**CAPITOL ZONING DISTRICT COMMISSION
STAFF REPORT
10/26/2016
TDM / BIM**

Location: 1424 South Main Street
Applicant: Matt Foster
Permit Types: Certificate of Appropriateness

Project Description: The applicant seeks a Certificate of Appropriateness to demolish the structure located at 1424 South Main and to construct a new two-story mixed-use building. The applicant also seeks a Conditional Use Permit to use the second story of the new building as multi-family residential. The building will be covered mostly with brick with glass and wood storefront facades on the ground level, balconies for the residences on the second level, and covered roof-top decks on the top. Both the 15th and Main Street sides will be built to the lot line adjacent to the sidewalks. Parking will be located at the rear, with some additional space potentially located across the alley as part of a shared parking agreement with a nearby property. No specific uses for the ground floor rental spaces are being proposed at this time.

South (top) and East (bottom) Elevations

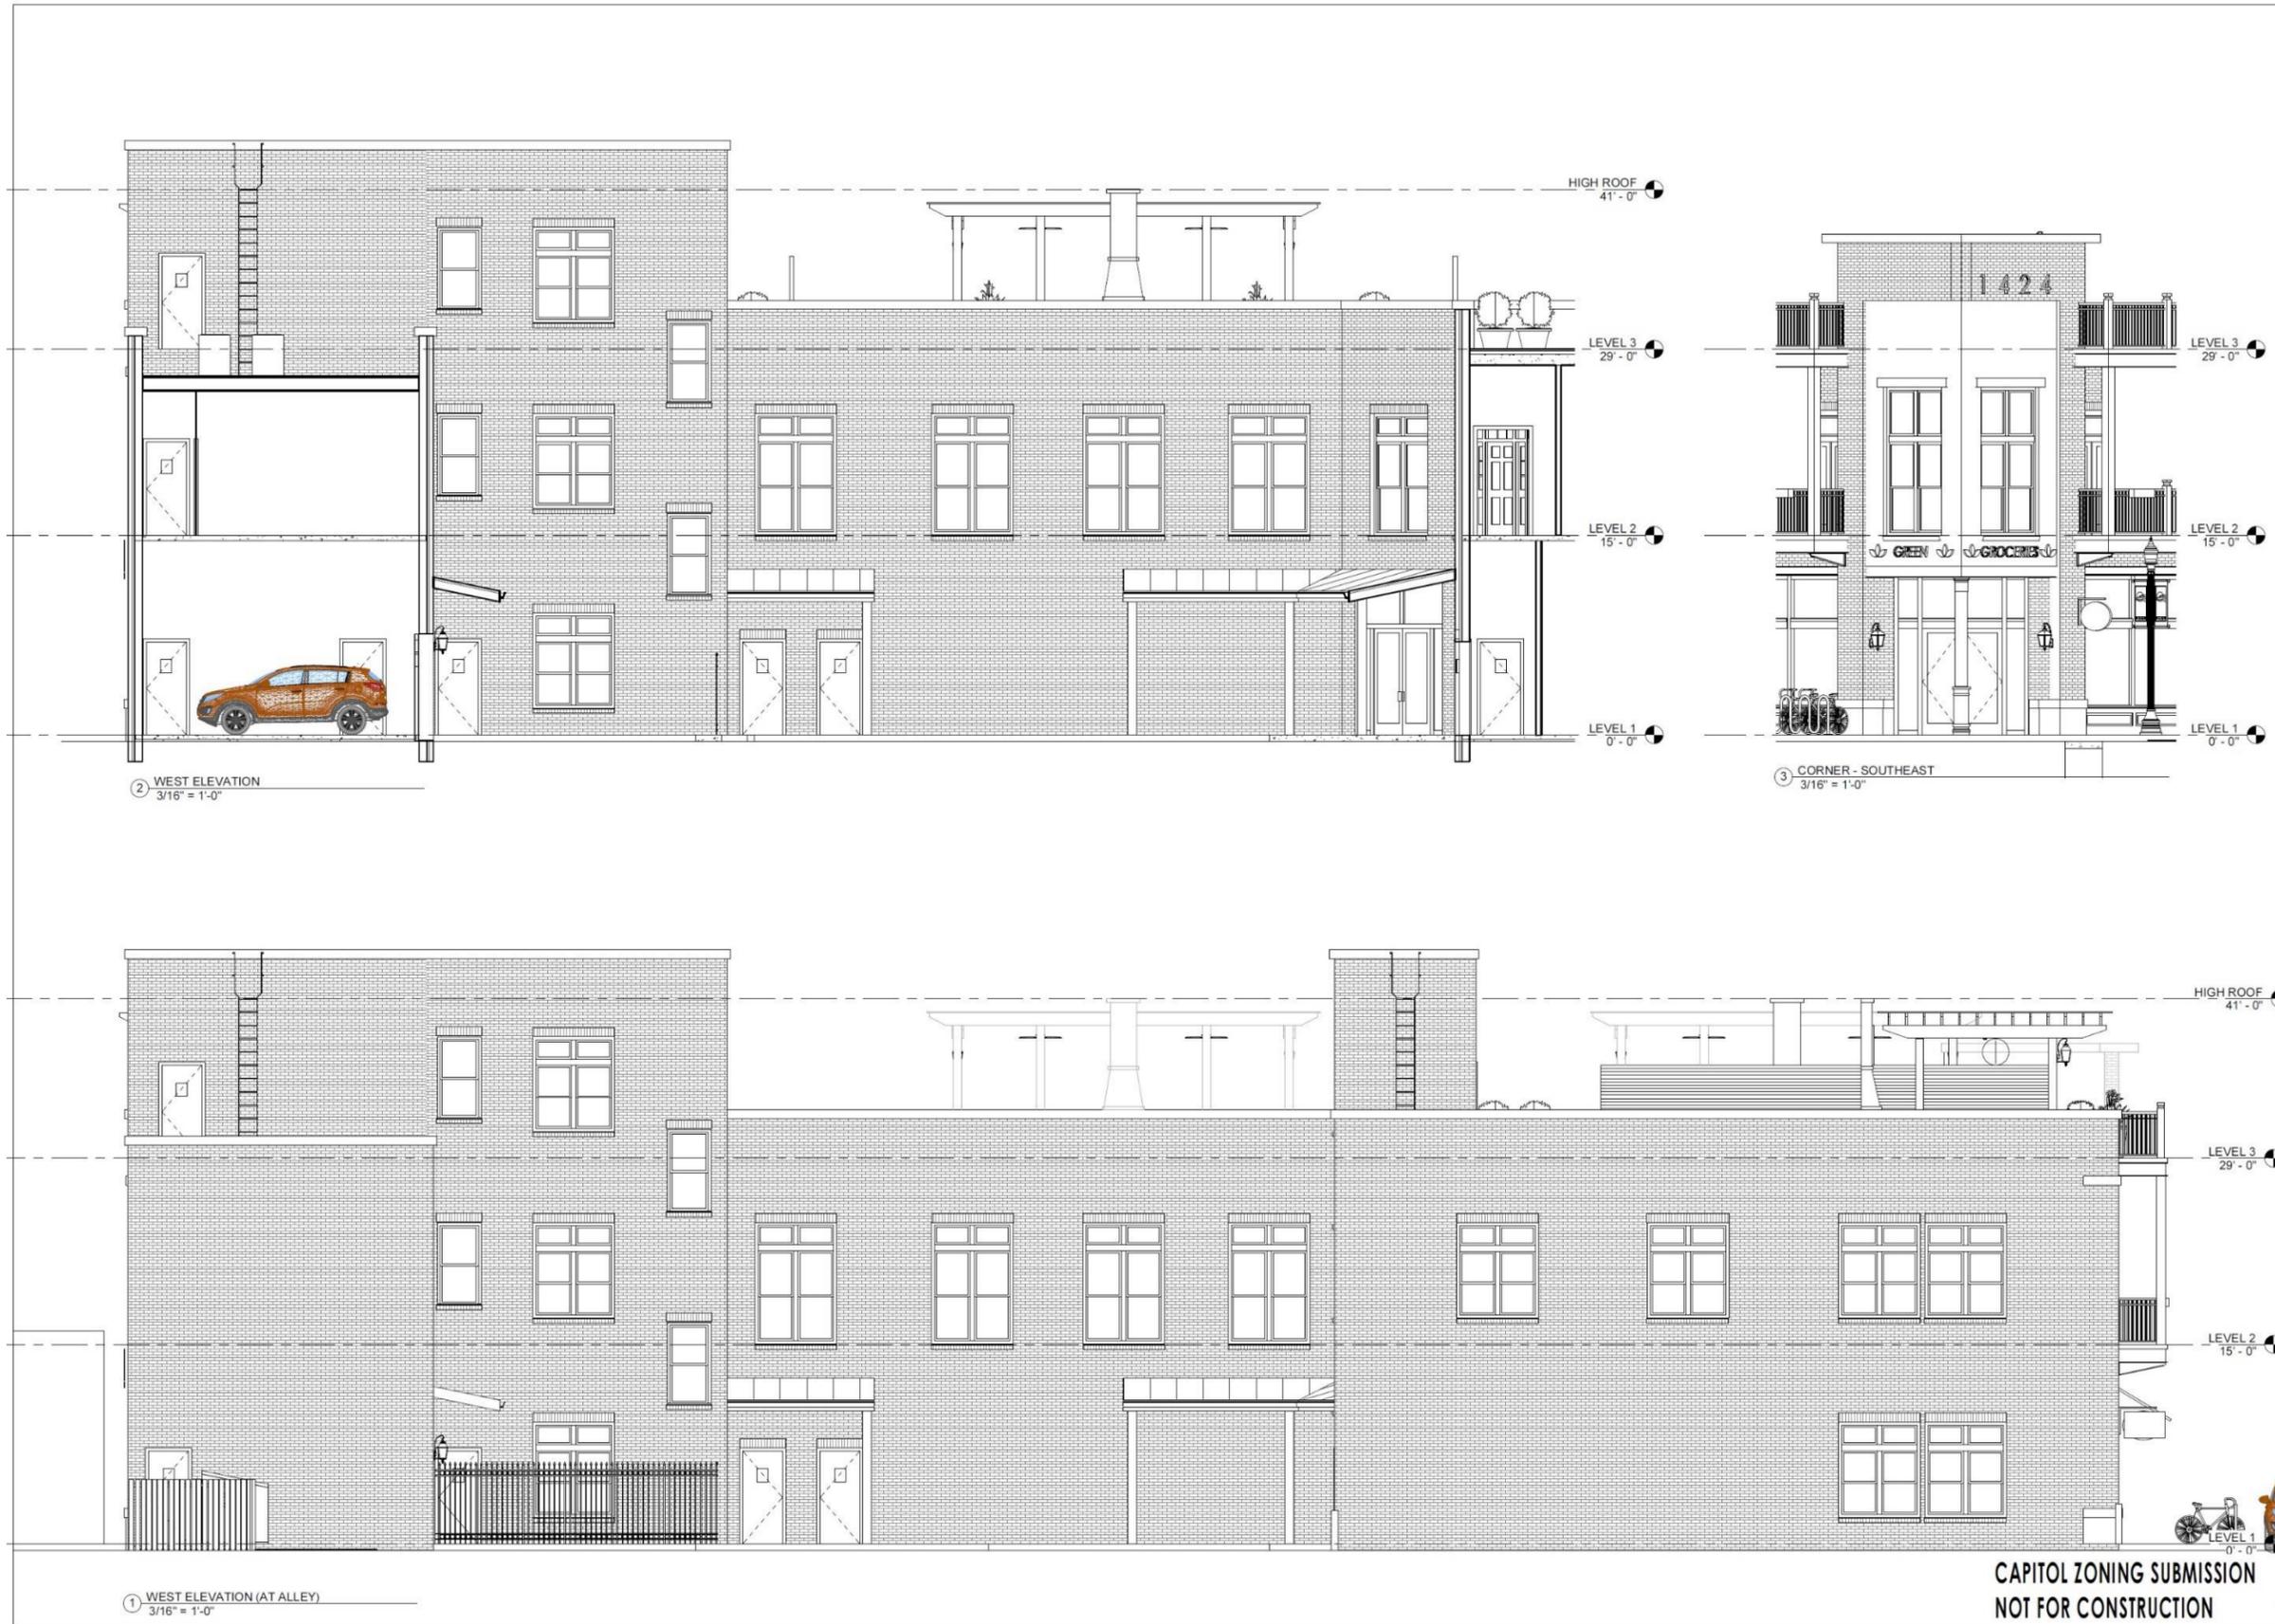
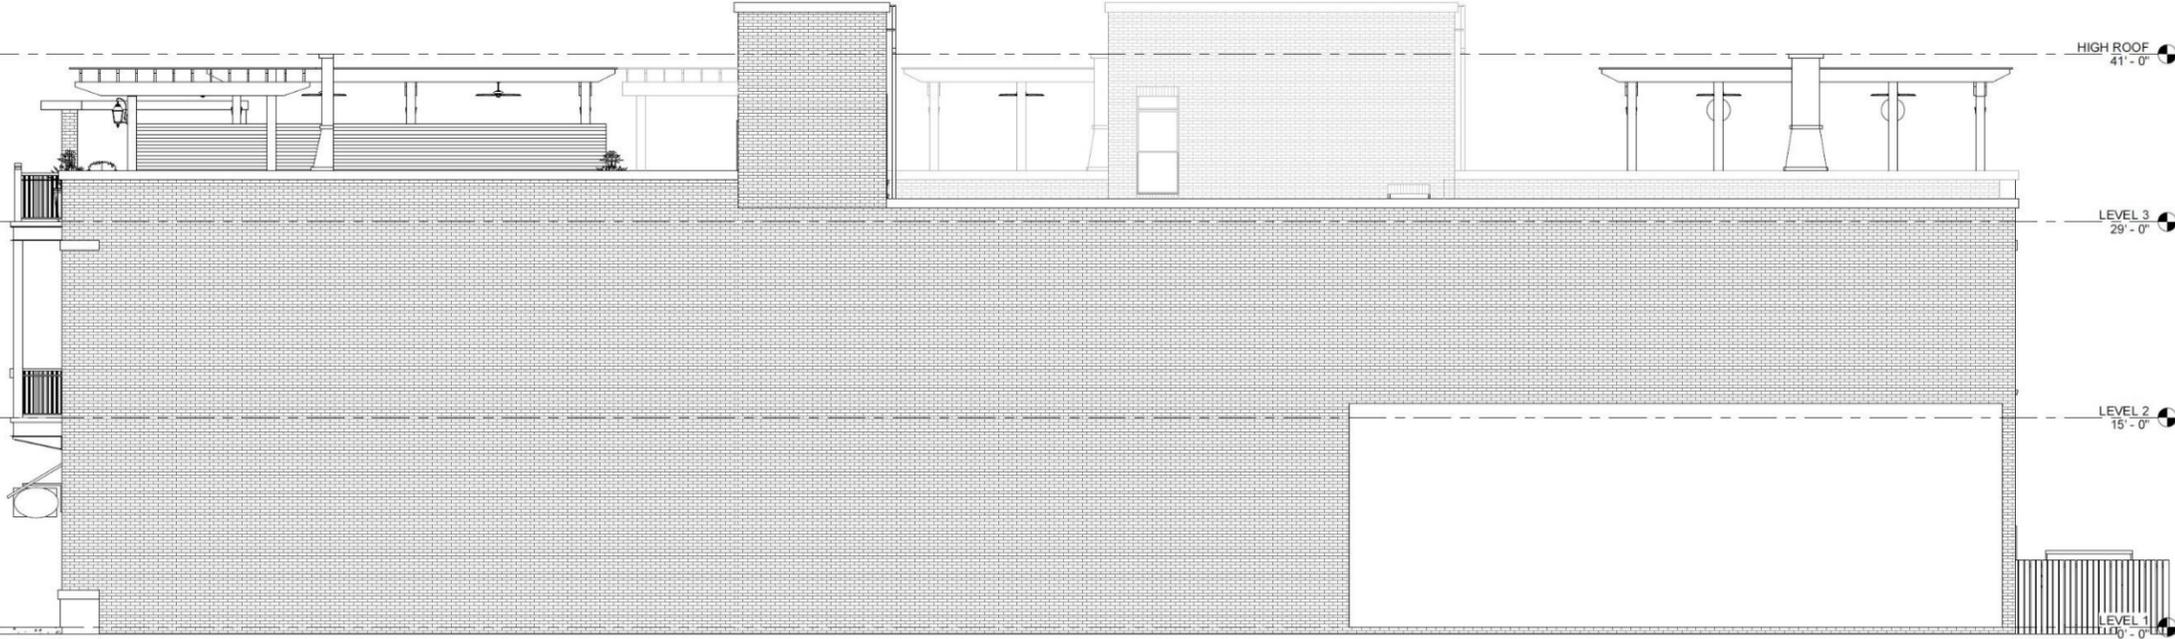
Staff finds the proposal to be mostly consistent with these standards. The height meets Standard O3, but the overall width exceeds the 50' recommendation in O4, both on the Main Street and 15th Street sides. While the proposal does not include a change in design features to break up the width, the design does include strong vertical breaks in the masonry facade every 40'-50' along both sides. A more significant break would be possible with changes in brick layout on the different modules, selecting different railing designs for the balconies and rooftop decks, specifying slightly different storefront details etc.

Staff finds the proposal to be mostly consistent with this standard. The balcony and rooftop deck articulations are significant. However, these recesses on the upper level with projecting balconies also serve to break up the long 150' and 140' faces of the building.

Staff finds the proposal to be mostly consistent with this standard. The overall layout of the building consists of two public-facing fronts instead of one front and a side. Given the strong presence of the balconies and rooftop decks, staff feels that stepping down the 15th Street parapet would not serve the intended purpose.

Staff finds the proposal to be mostly consistent with this standard. The primary facades consist largely of traditional storefronts on the first floor. However, the distinction between the floors is not emphasized except through the use of taller windows and transoms on the lower level. A belt course in the brick work would be easy to implement.

Staff finds the proposal to not be consistent with this standard. No recessed entrances are proposed, except for the corner entrance.
